Land at Coleshill Street Miles Platting

Drawing number	Rev
3547A - LEV - 00 - XX - DR - A - 1701	P3
Drawing

Plot K - Proposed Courtyard Sections

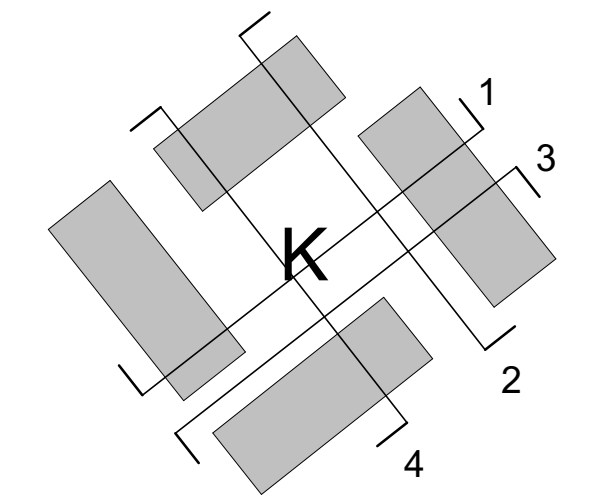
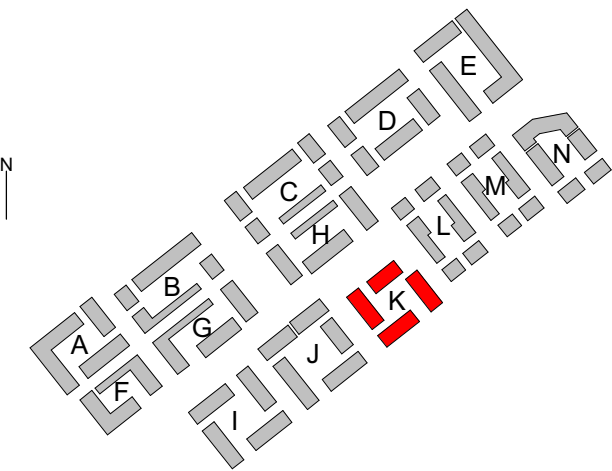
Item 07.
Change pre-cast
concrete canopies to
houses to PPC pressed
aluminium clad
canopies which retain
the same size and form.

Item 07.
Change pre-cast
concrete canopies to
houses to PPC pressed
aluminium clad
canopies which retain
the same size and form.

Item 07.
Change pre-cast
concrete canopies to
houses to PPC pressed
aluminium clad
canopies which retain
the same size and form.

Item 18.
Change pre-cast
concrete dwelling
garden dividers to the
Canal Tow Path houses to
brick walls retaining
house numbering

Item 19.
Omit pre-cast concrete
cladding to Tow Path
facing houses with
textured brick detailing

Corrugated metal cladding
omitted.
Blue/grey Facing Brickwork
Type 4 added which applies
to Mews houses
Facing brickwork with
recessed banding adds to
top floor of Apartment Blocks
E, J and N

- 06 Railing/Gate – mild steel, PPC finish – RAL 7021 or similar
- 07 PPC aluminium canopy
- 08 Intercom system brushed stainless steel finish
- 09 Planter Balustrade – recessed planting trough – RAL 7021 or similar

- 17 Dark stained timber pergola/visual screen
- 18 Dwelling divider – light coloured facing brickwork (500mm(h) x 200mm(w))
- 19 Facing brickwork with recessed/projecting pattern - colour to match adjacent brick
